From: willie.m88@gmail.com [mailto:willie.m88@gmail.com] **On Behalf Of** William Micklin
Sent: Wednesday, January 19, 2011 2:10 PM
To: Greg Thomsen
Cc: Iain Fisher; John Rydzik; jerry.pell@hq.doe.gov; Jesse Bennett; Rica Nitka; Michael Garcia
Subject: DEIR-EIS Setbacks on Tribal Lands

Tule Wind Project

EIR Required Setbacks on the Ridge

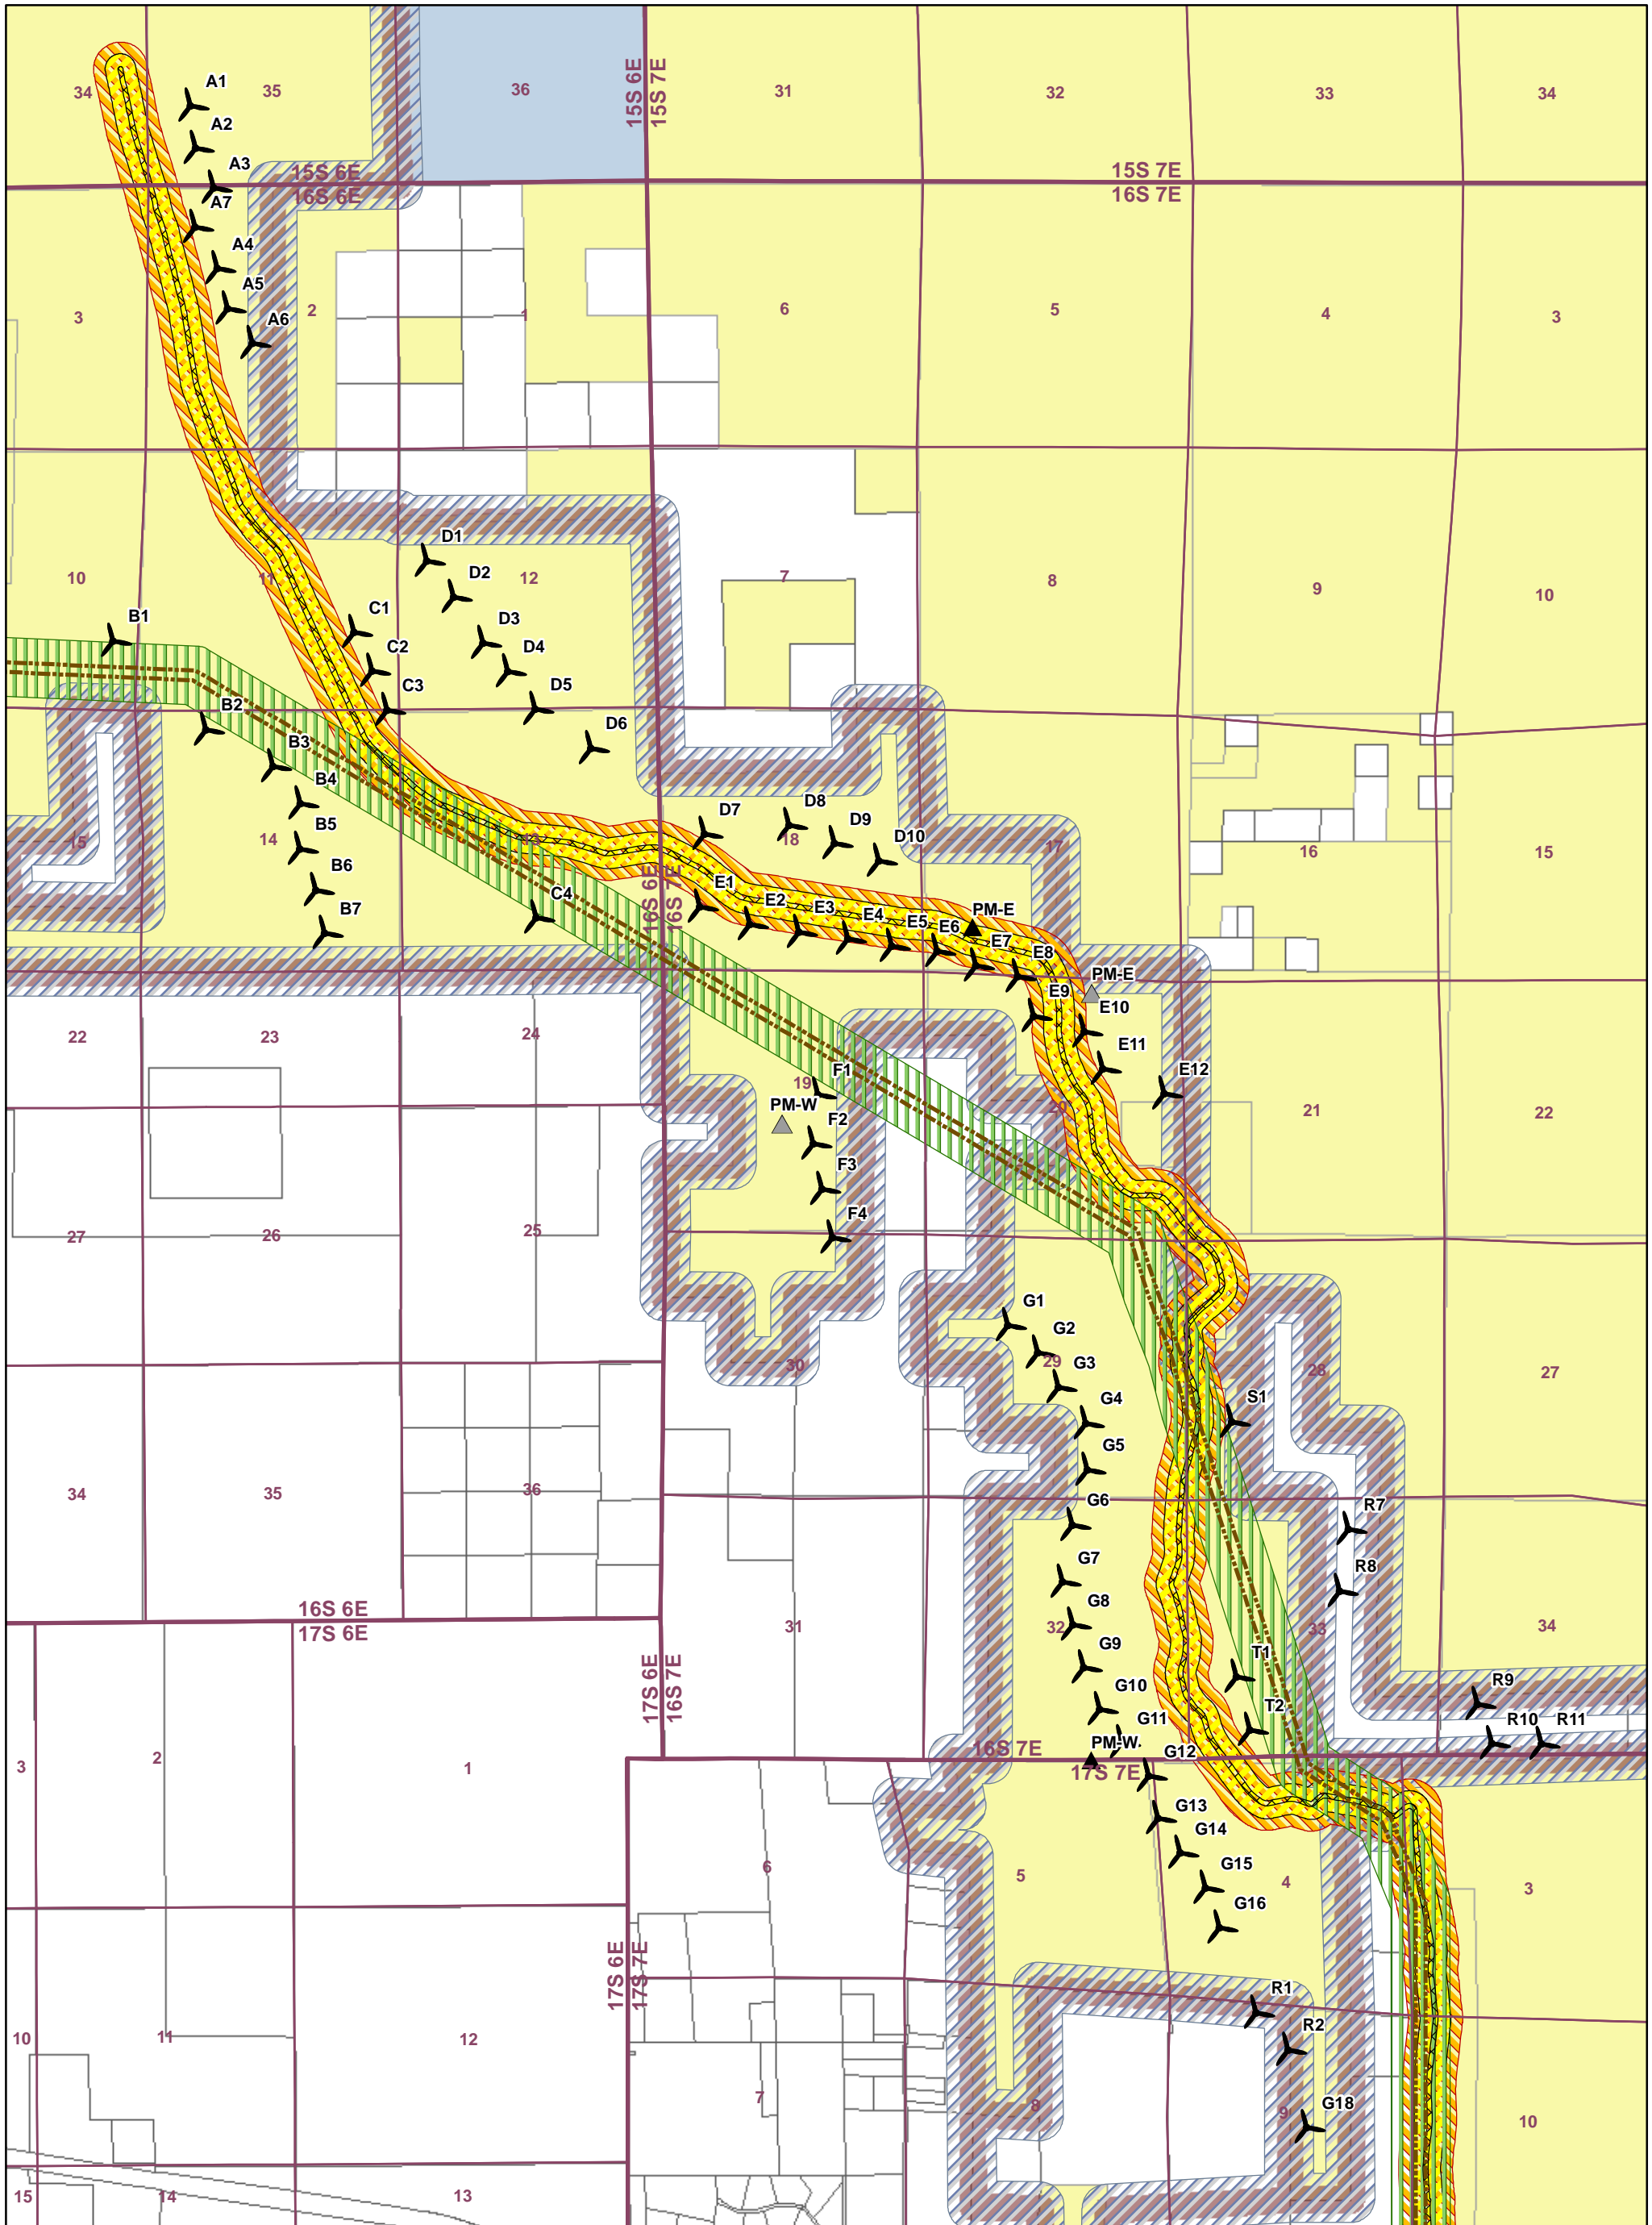
Analysis of the DEIR-EIS for the portion on the Ewiiapaayp Indian Reservation of the Tule Wind Project and the DEIR-EIS recommendations for setbacks (see attachments) shows that the effect of the setbacks would be to eliminate 9 or the 17 turbines on tribal lands. This proposed reduction is unacceptable to the Tribe would occur even if we were to resolve the DEIR-EIS recommendation that all turbines on the tribal lands be eliminated as a conservation restriction to mitigate the potential for take of golden eagles (which is unacceptable to the Tribe as well). Although the setbacks are nominal, because the turbine site locations are on a steep and narrow ridge of the Reservation, any such setback would be impractical and would eliminate the 9 turbines.

The NEPA environmental analysis has not adequately or reasonably considered the unique governmental rights or interests of the Tribe. The Tribe is requesting the this setback be eliminated for the tribal lands.
